Illinois Tollway Standard Drawings Revisions

Section L Base Sheet Drawings		
Drawing	Modification Summary	Effective: 03-01-2021
L1 Fiber Optic System Typical and Drawings		
Sheet 1	Updated General Note #4 to include "Fiberglass Reinforced Epoxy (FRE) conduit may be used above ground or underground (as casing) per the Special Provisions. HPDE conduit casing may be used underground."

VERSION: 2021-03	STANDARD: L1-03	SHEET: 4 OF 15
---------------------	--------------------	-------------------

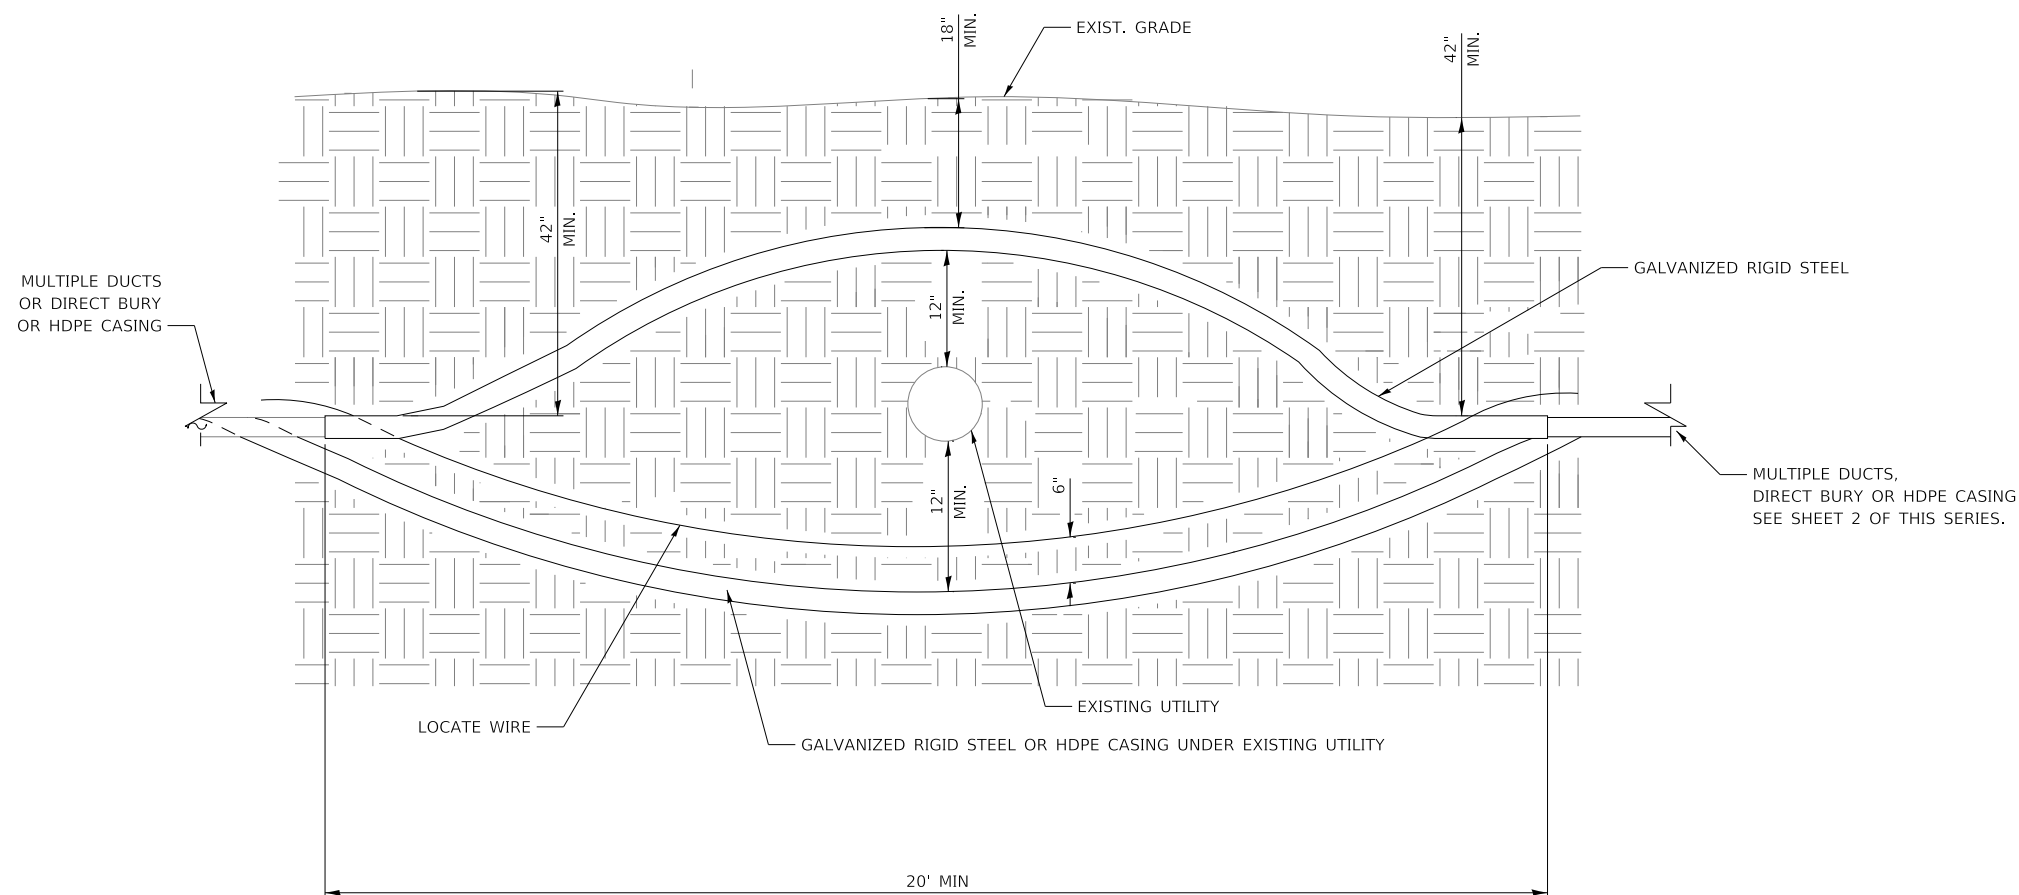
Sheet 2	Changed "1 1/4 in. and/or 1 1/2 in. ID" to "CNC Ducts".	
Sheet 4	Added word "minimum" to Note #4.	
Sheet 4	Removed warning tape from image.	
Sheet 5	Removed duct sizes from images.

VERSION: 2021-03	STANDARD: L1-03	SHEET: 5 OF 15
---------------------	--------------------	-------------------

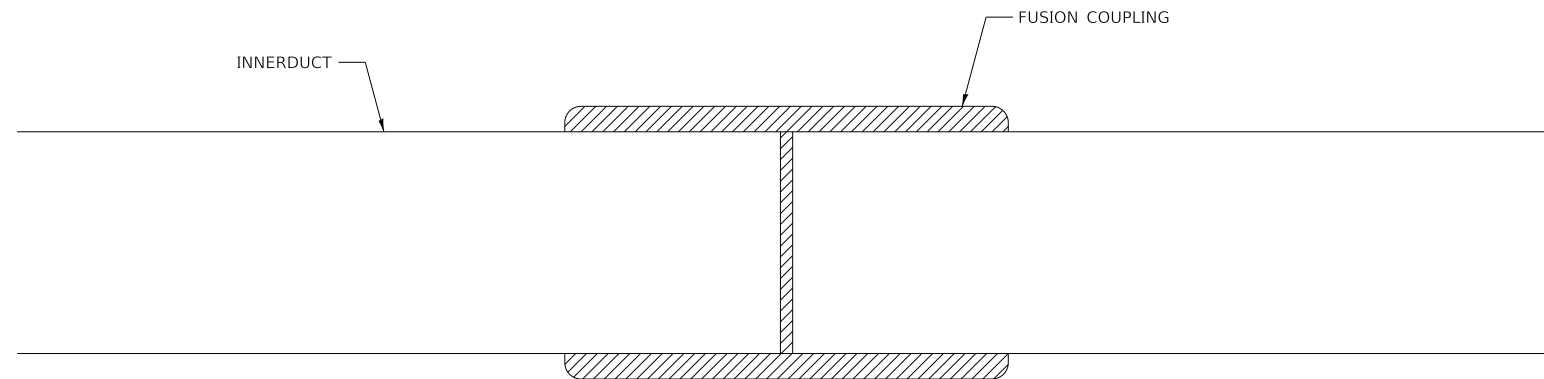
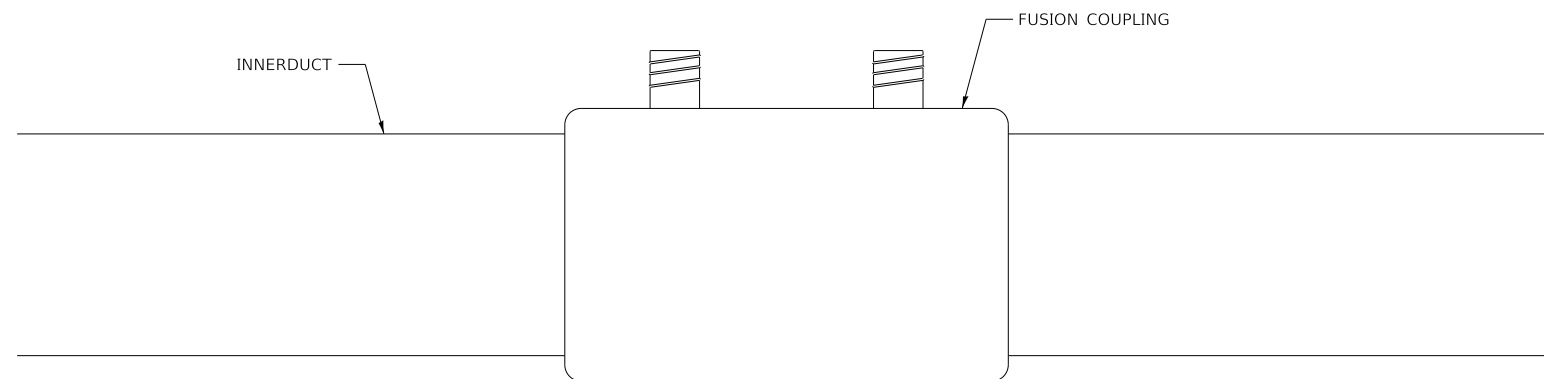
Sheet 5	Added language that allows for compression coupling.	
Sheet 6	Removed duct sizes from images.	
Sheet 8	Updated callout to include "...for none splice handholes. Provide a min. of 100' slack coil for handholes containing splice case(s), 50' on either side of splice case.

VERSION: 2021-03	STANDARD: L1-03	SHEET: 8 OF 15
---------------------	--------------------	-------------------

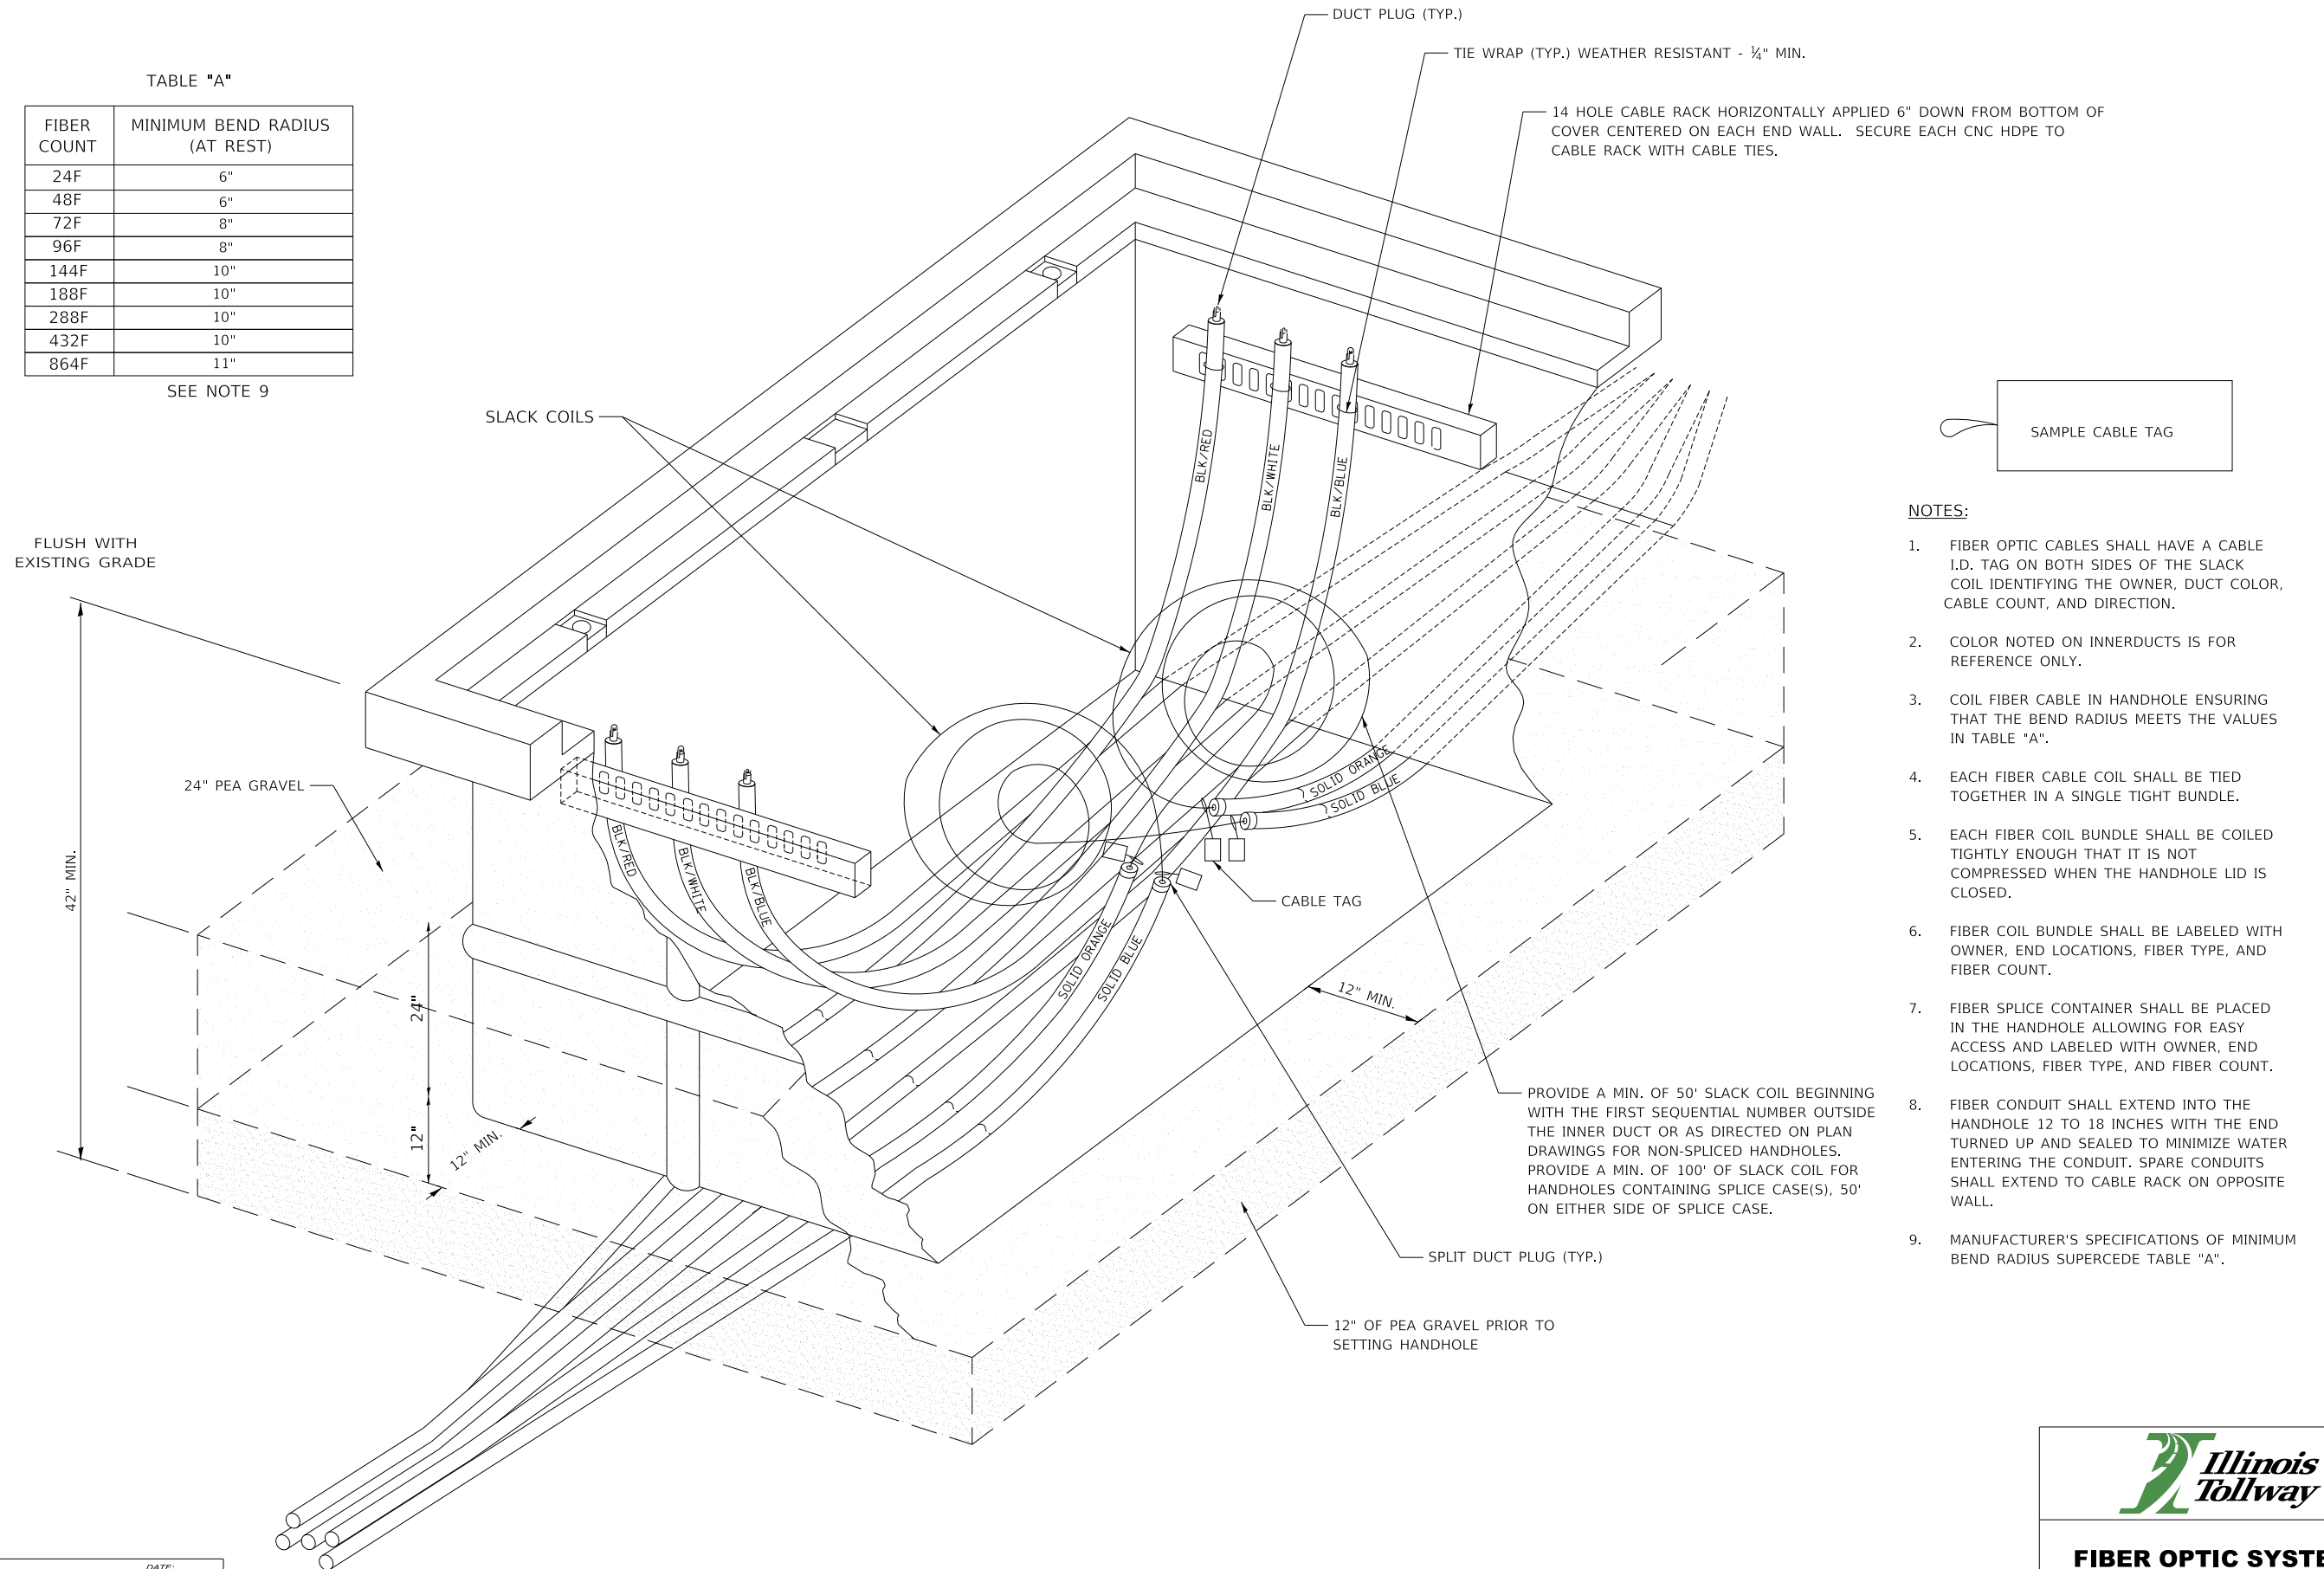
Sheet 8	Replaced conduit size with "CNC".	
Sheet 9	Removed note "Place 1 1/4" HDPE over fiber optic cable to provide crush protection extend HDPE 1" inside handhole."

VERSION: 2021-03	STANDARD: L1-03	SHEET: 9 OF 15
---------------------	--------------------	-------------------

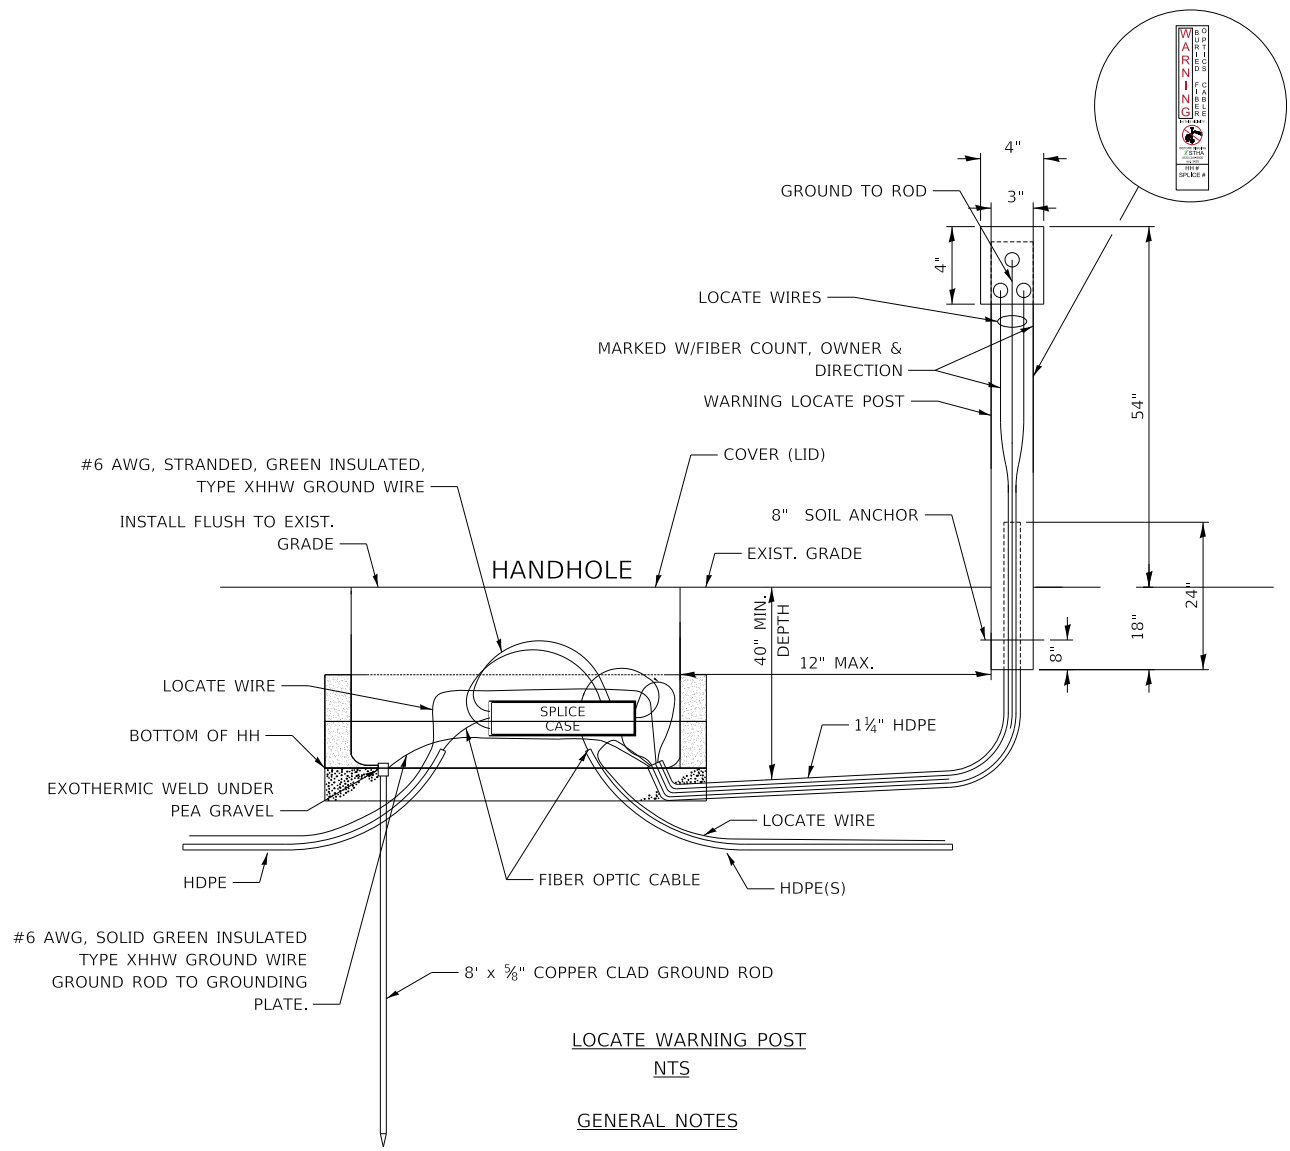
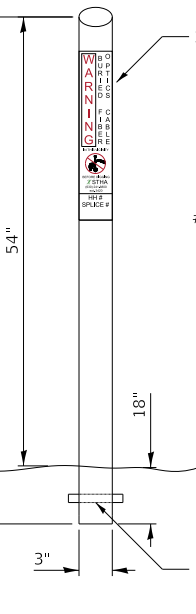
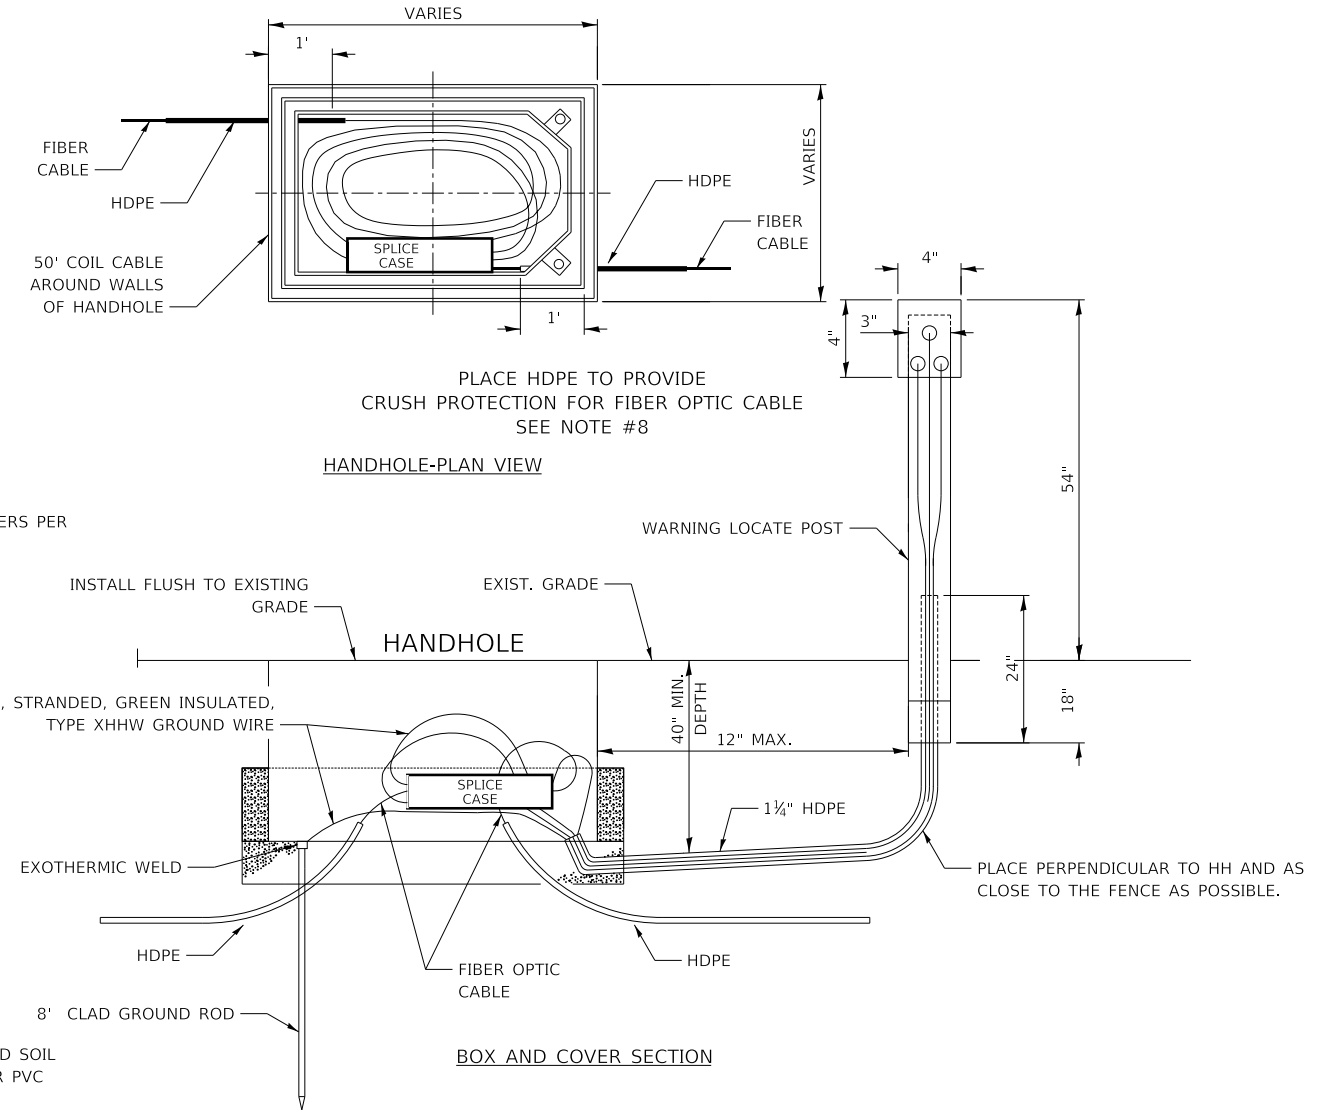
Sheet 9	Removed "Placed 1 1/4" HDPE" from Handhole - Plan View.	
Sheet 10	Removed note "Place 1 1/4" HDPE over fiber optic cable to provide crush protection extend HDPE 1" inside handhole."
